ADDENDUM NO. 2, APRIL 23, 2009

RE: Ocean Avenue Elementary School  
Portland, Maine  
A/E Comm. No. 3316.10

City of Portland RFP No. 7109  
BGS project No. 723

ADD2-EP102-B-1

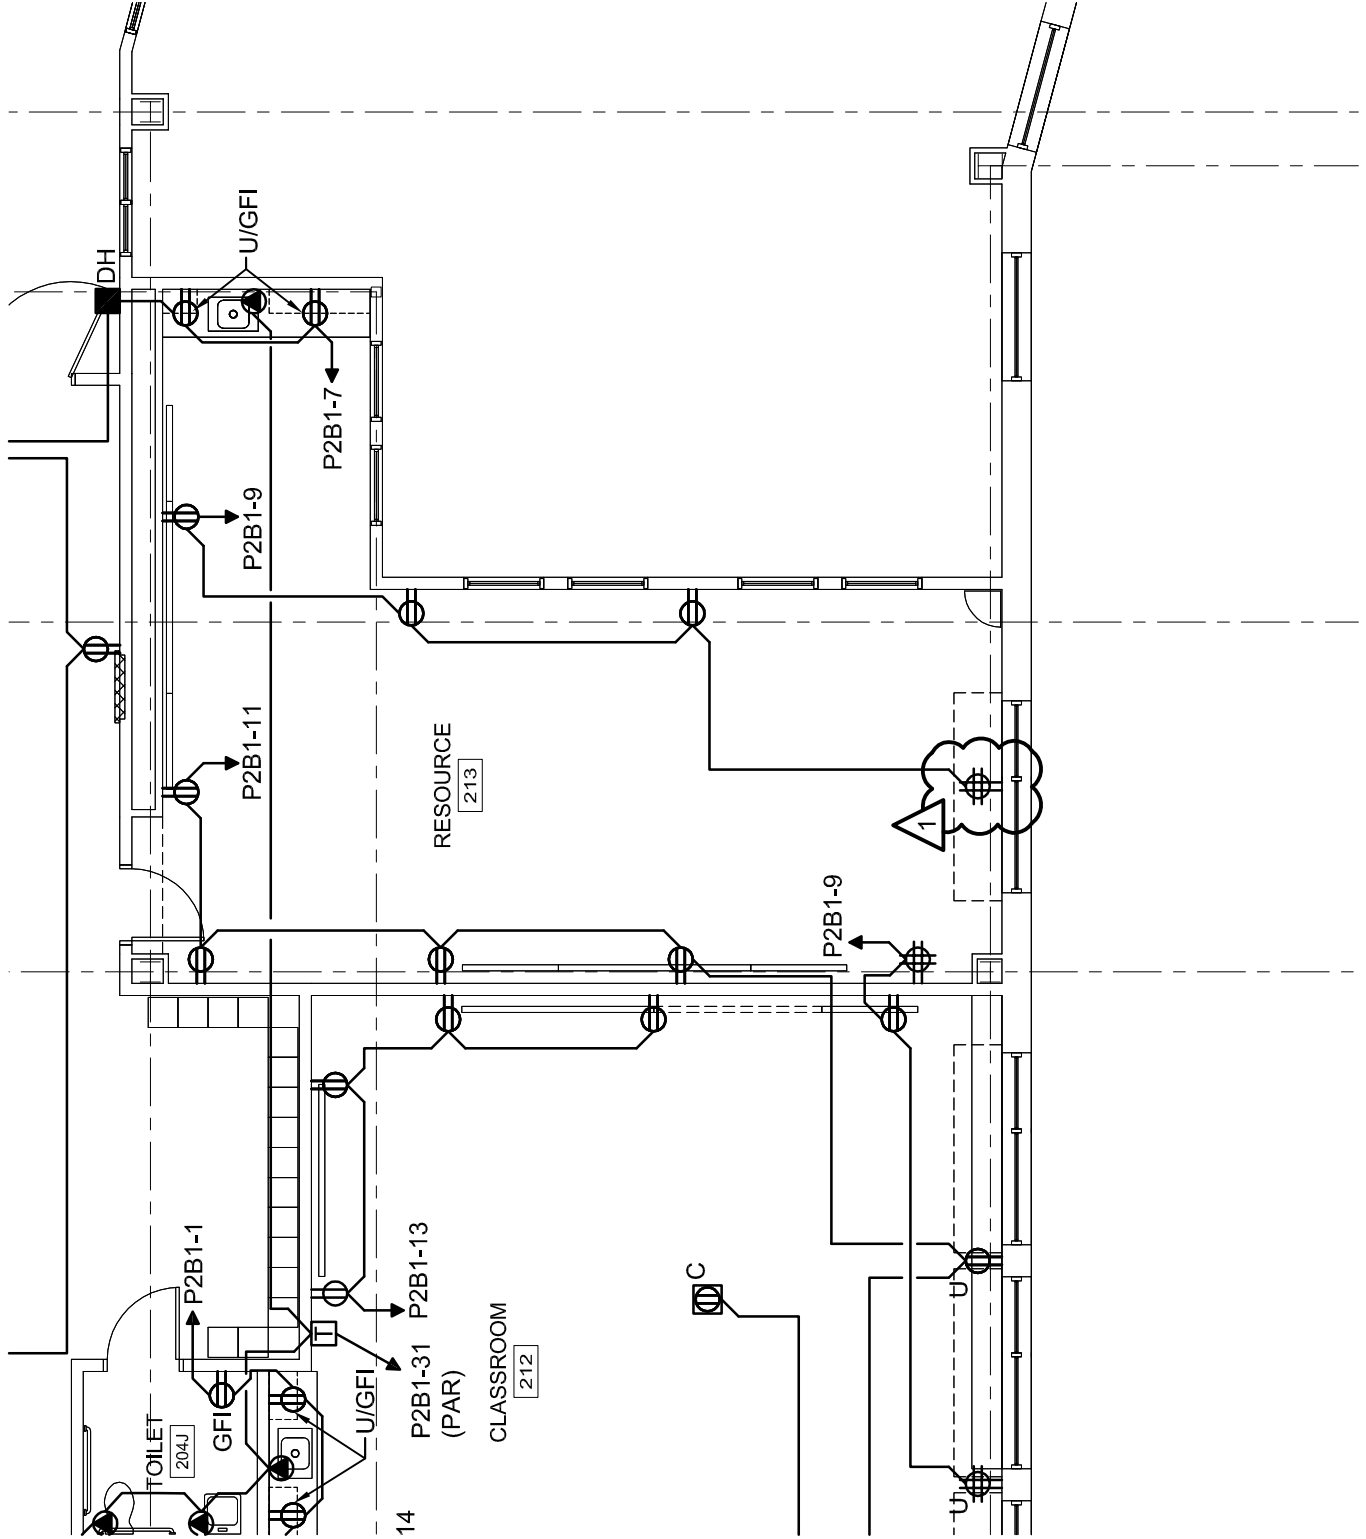
36. Sheet EP101-C, First Floor Electrical Power Plan – Seg. C, REVISE portions as indicated on attached Sketch ADD2-EP101-C-1.
37. Sheet EP102-B, Second Floor Electrical Power Plan – Seg. B, REVISE portions as indicated on attached Sketch ADD2-EP102-B-1.

**ADD2-EY101-B-1**

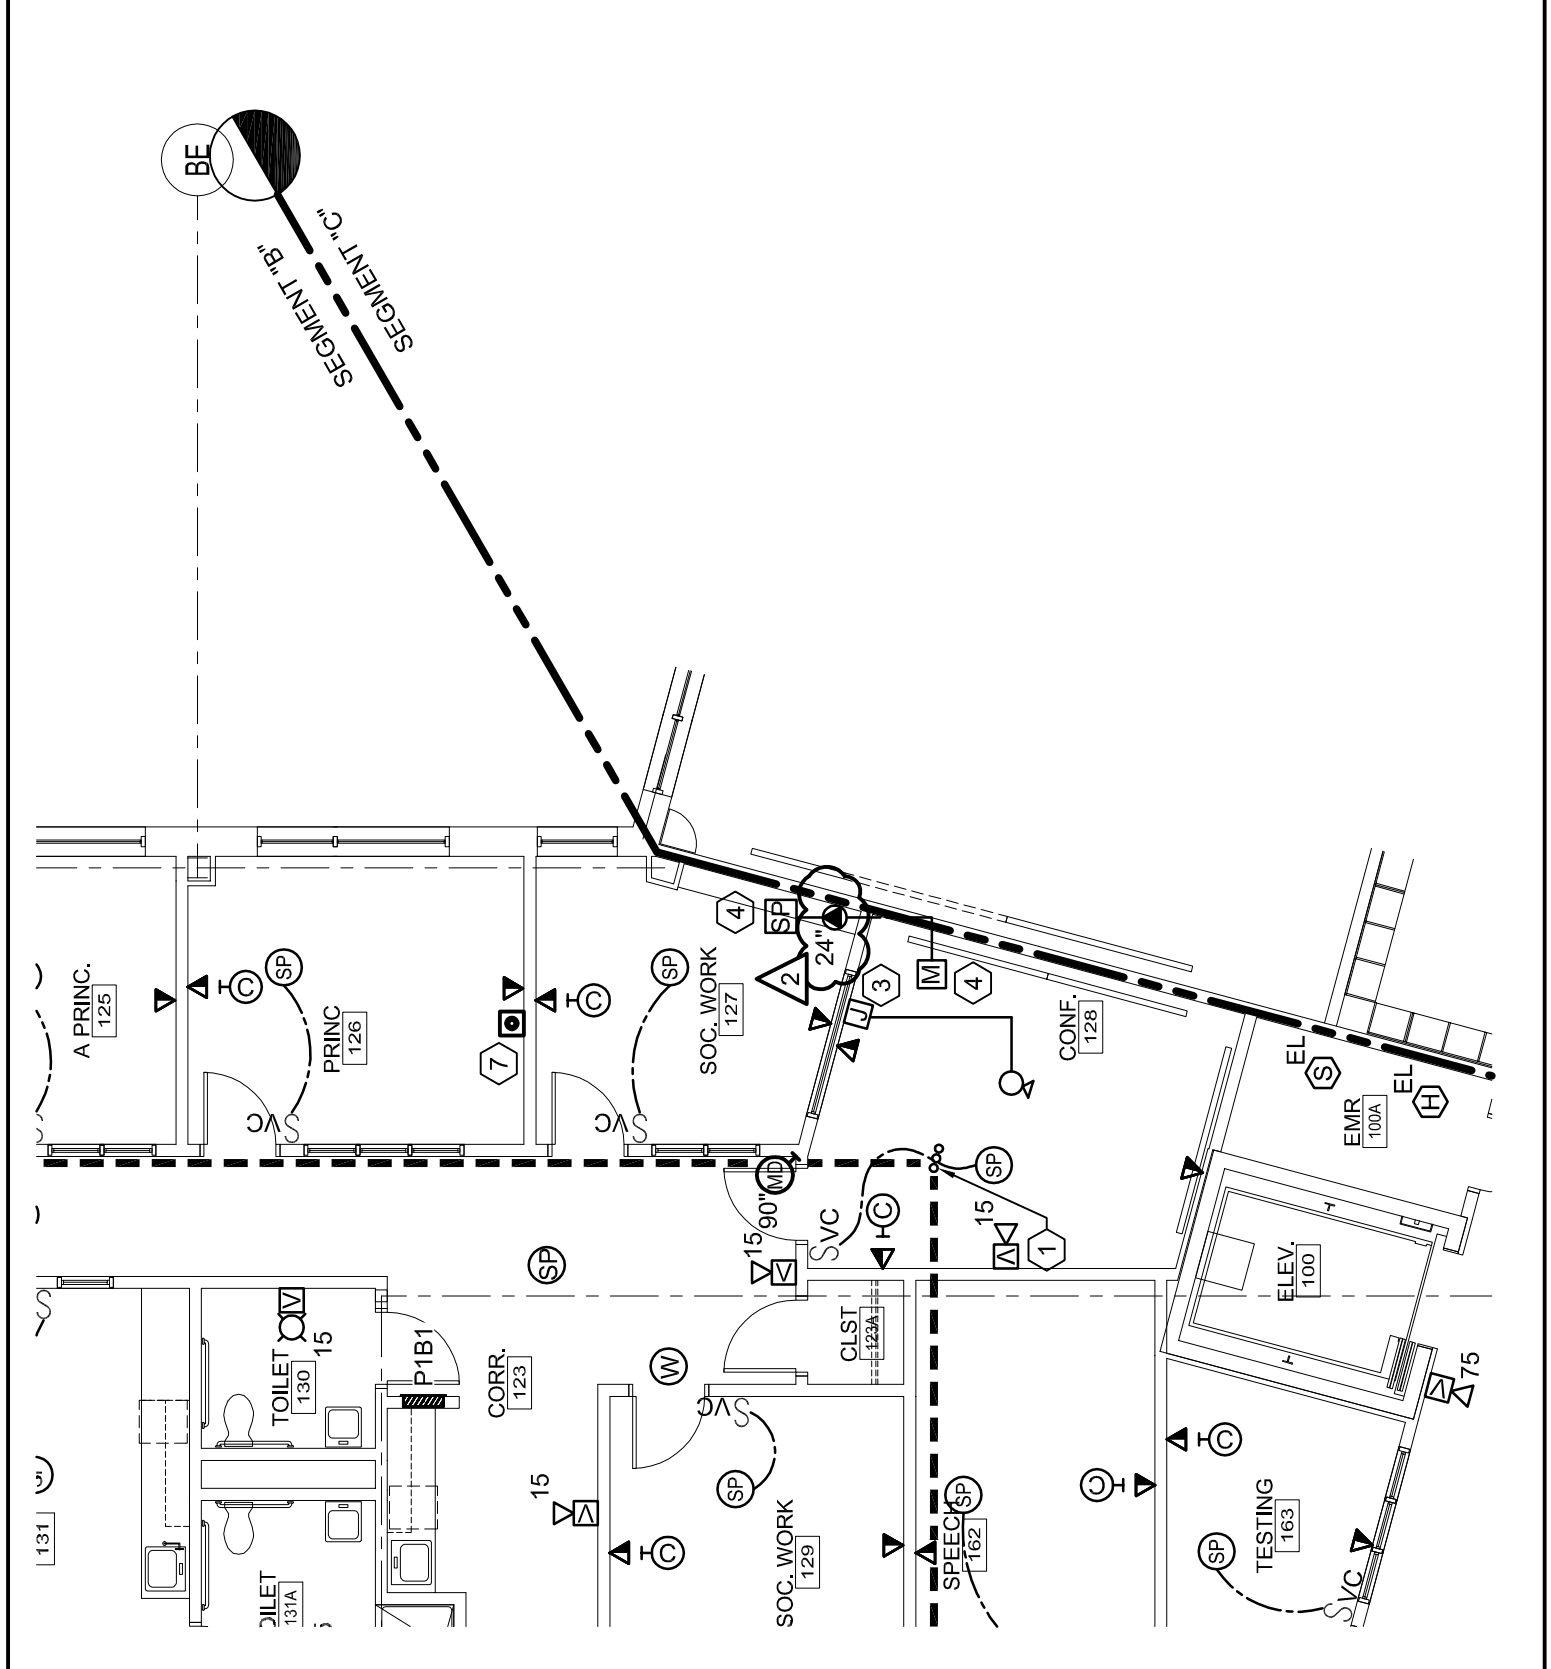
38. Sheet EY101-B, First Floor Electrical Systems Plan – Seg. B, REVISE portions as indicated on attached Sketch ADD2-EY101-B-1.
39. Sheet EY101-C, First Floor Electrical Systems Plan – Seg. C, REVISE portions as indicated on attached Sketch ADD2-EY101-C-1.
